AMENDED BY STAFF 12-18-86
CITY PLANNING COMMISSION

- APPLICATION:**
- A. Negative Declaration
 - B. PUD Schematic Plan Amendment to add two residential units
 - C. Tentative Map
 - D. Special Permit to develop 26 zero-lot-line units in the University Park PUD
 - E. Amend condition of approval of P-8312 to add two residential units
 - F. Variance to have driveways less than 20 feet deep
 - G. Subdivision Modification to create revise frontage lots (withdrawn)

LOCATION: 120+ feet southwest of University Avenue and Breckenwood Way

TENTATIVE SUBDIVISION MAP
 UNIVERSITY
 ESTATES

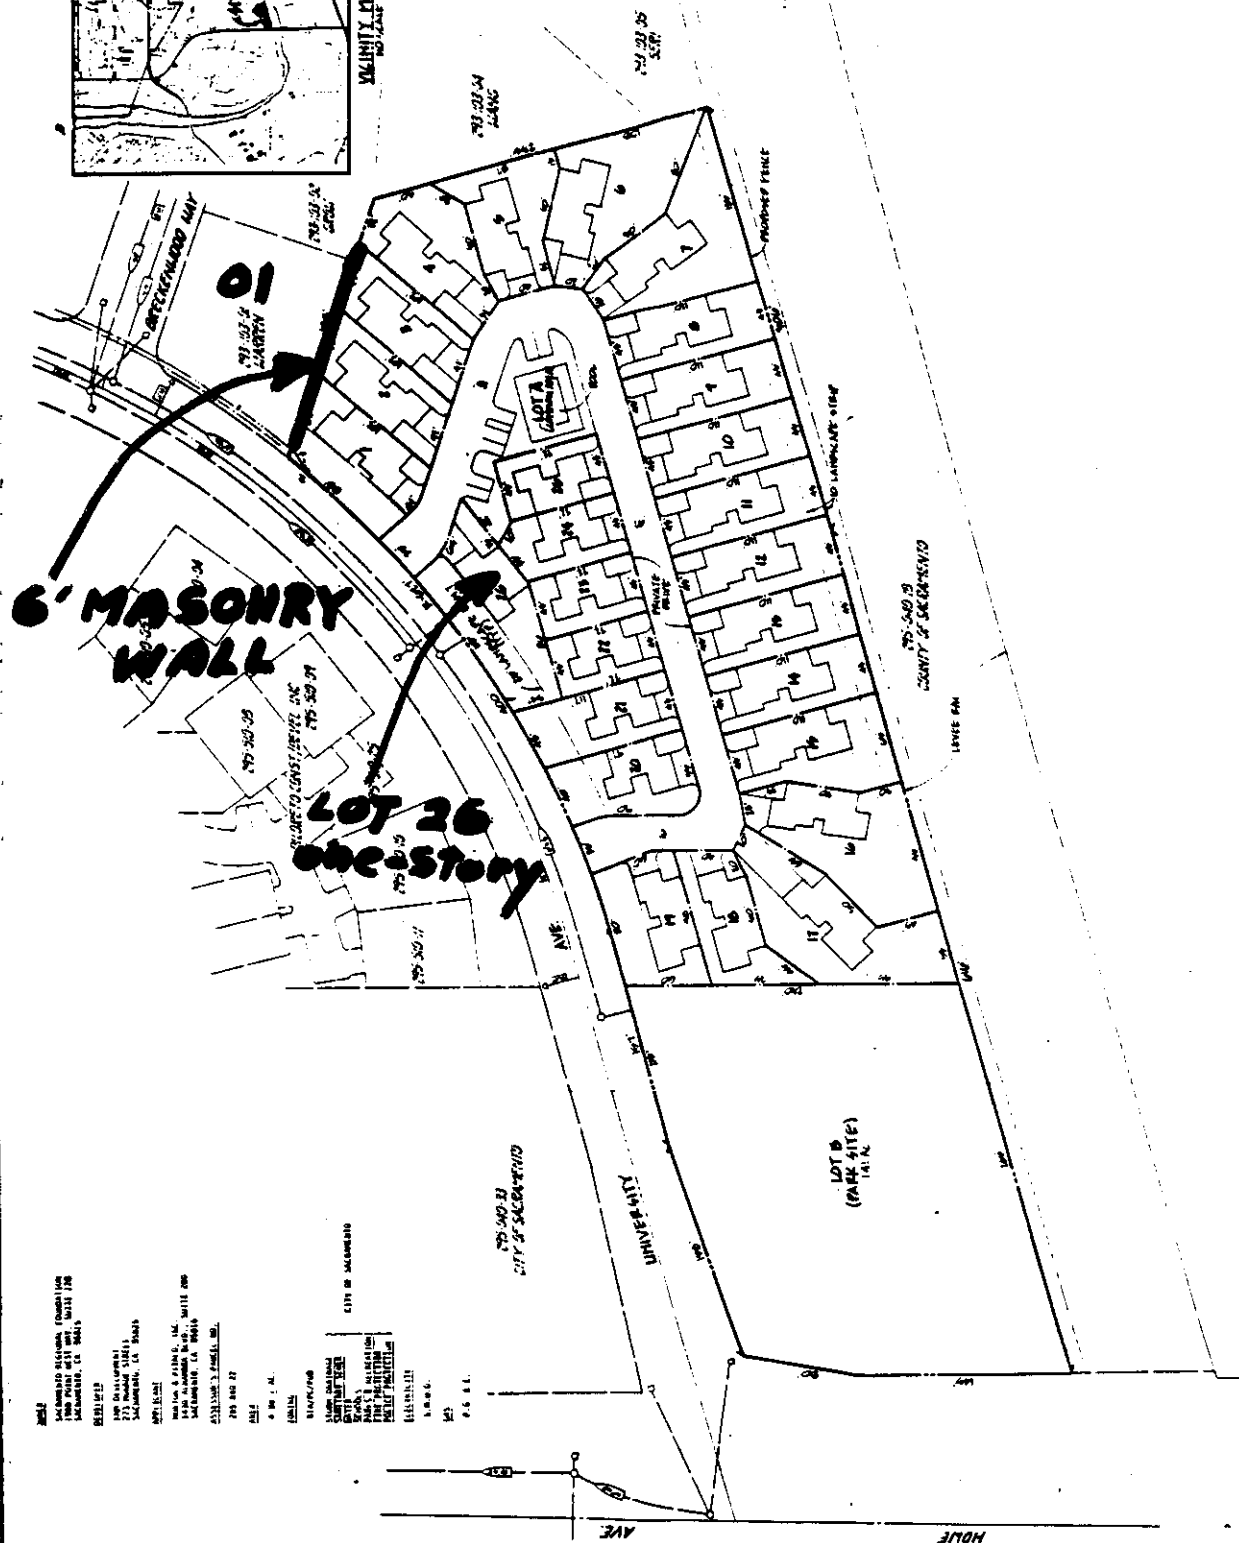
Lot 26 is irregularly shaped with a great deal of wasted space. Staff recommends that the rear portion of lot 26 be added to lot 22. This will expand the outdoor area of lot 22 and make lot 26 more regular in shape.

As the project is proposed, a subdivision modification is necessary to create reverse frontage residential lots which front onto University Avenue and the private street. Staff's recommended redesign, placing the landscaped setback in the ownership of the homeowners' association makes the subdivision modification unnecessary. Staff recommends that the request be withdrawn.

10. Indicate levee reference line on final map;
11. Redesign the map to make the 25 foot landscaped setback part of Lot A to be owned and maintained by the homeowners' association;

12. Dedicate the private road as a public utility easement and adequate space back of curb for public utilities;
13. Indicate easement across Lot A for lots 1 and 19 to gain access to the rear yard;

14. redesign the map to extend the rear of lot 22 to the 25 foot setback (Lot A);

UNIVERSITY ESTATES
 PLAN 2
 1525 sq. ft.

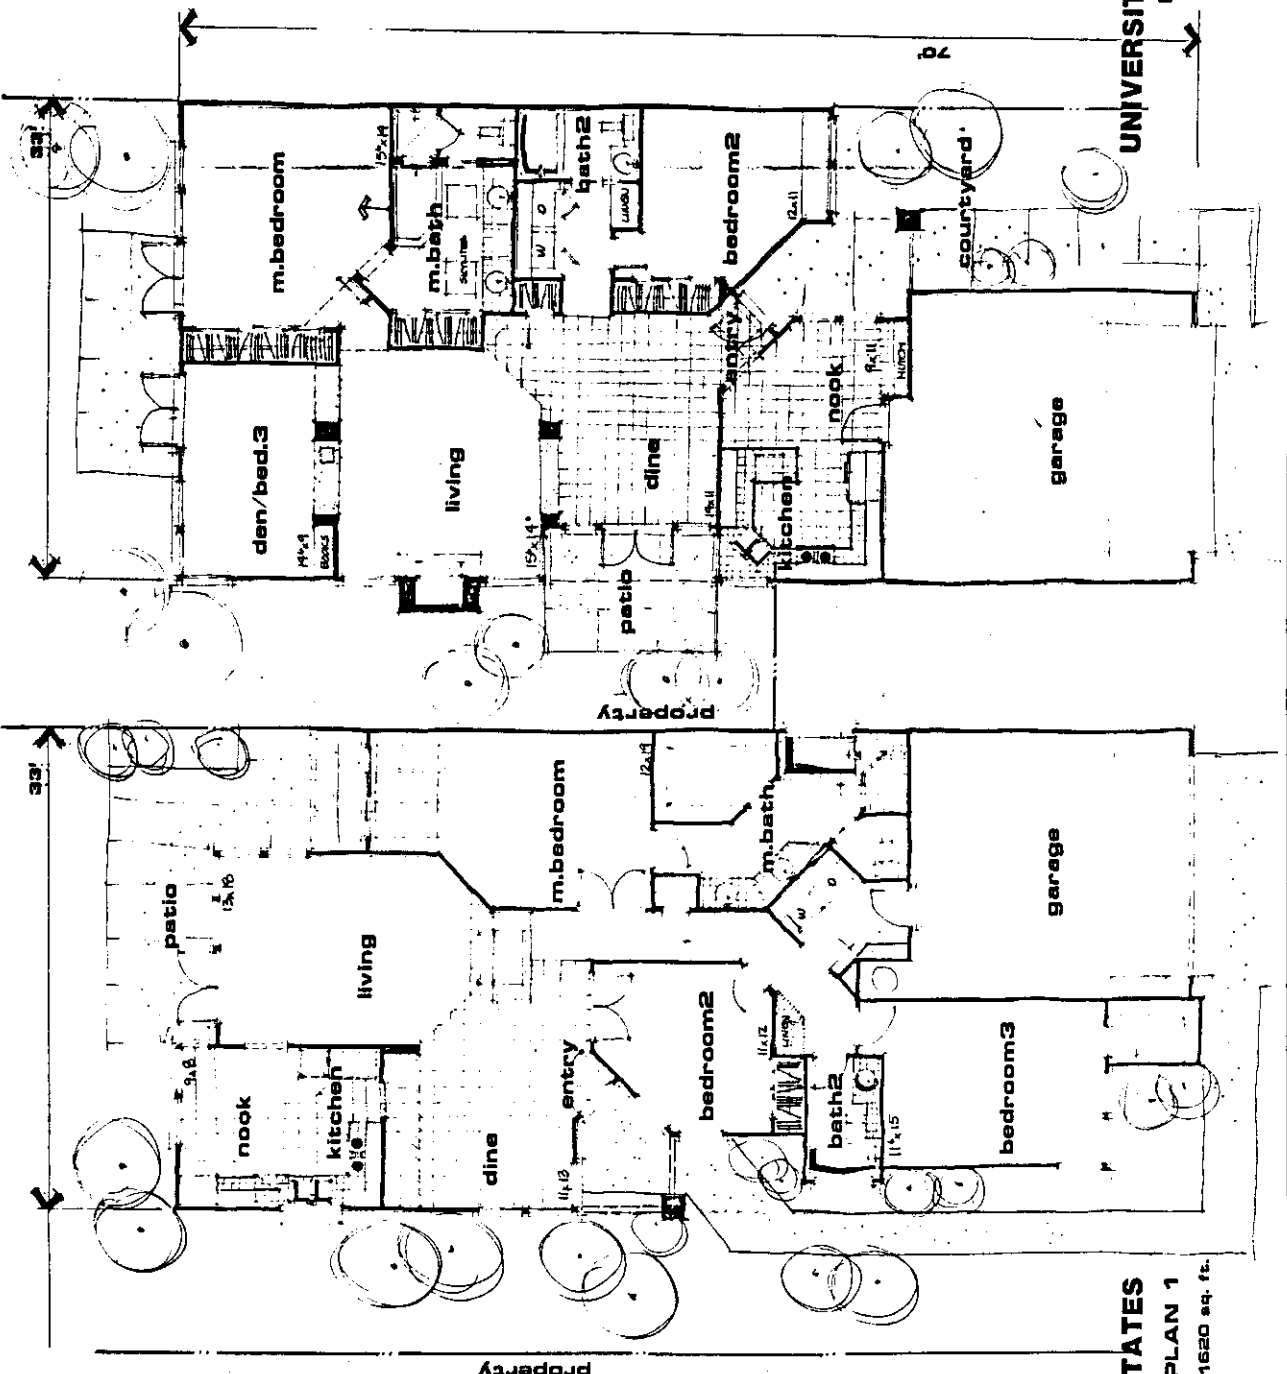
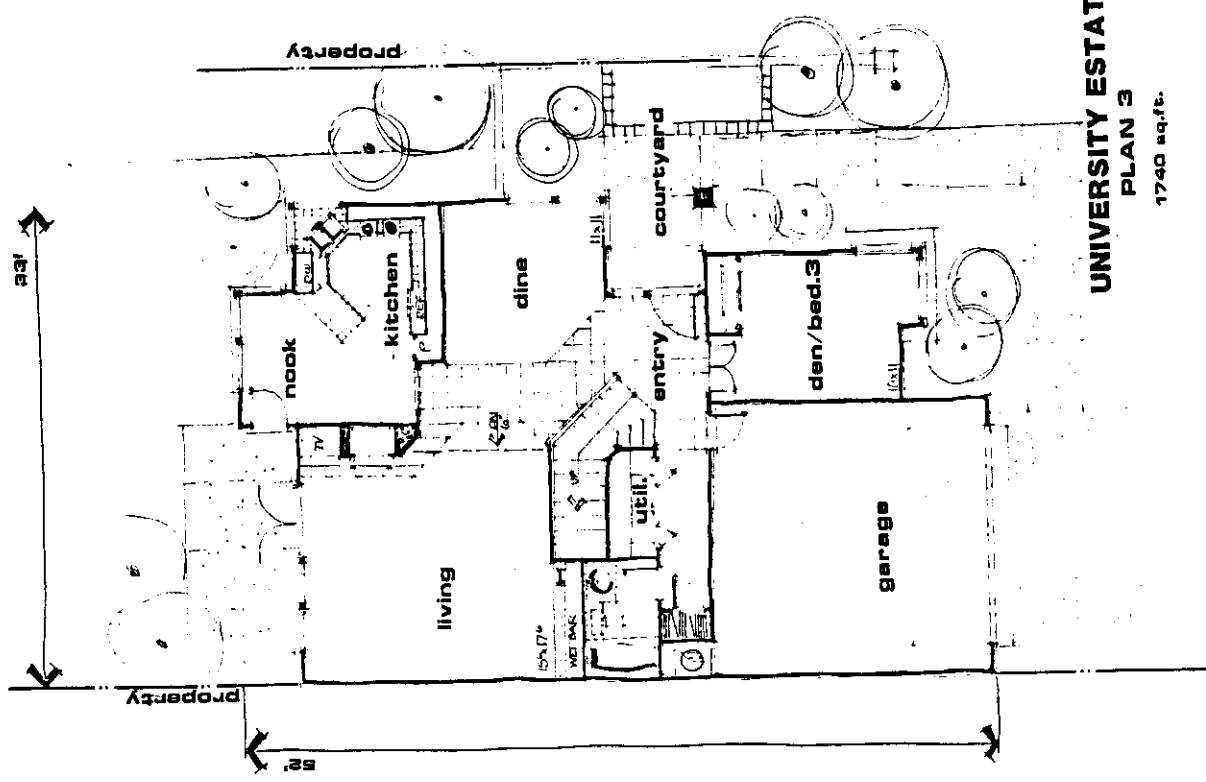
The applicant proposes three floor plans and elevations. There is one two-story model and two one-story models. Because of height requirements along the river parkway, the two story units are located north of the private street. Single story units are located along the parkway and adjacent to existing residential dwellings. Staff recommends that an equal number of each one-story unit be distributed along the private street. Building materials are to be horizontal wood siding on all elevations and medium shake roof. Front windows are small paned. Staff finds the floor plans and elevations acceptable and compatible with surrounding cluster townhouses and single family dwellings.
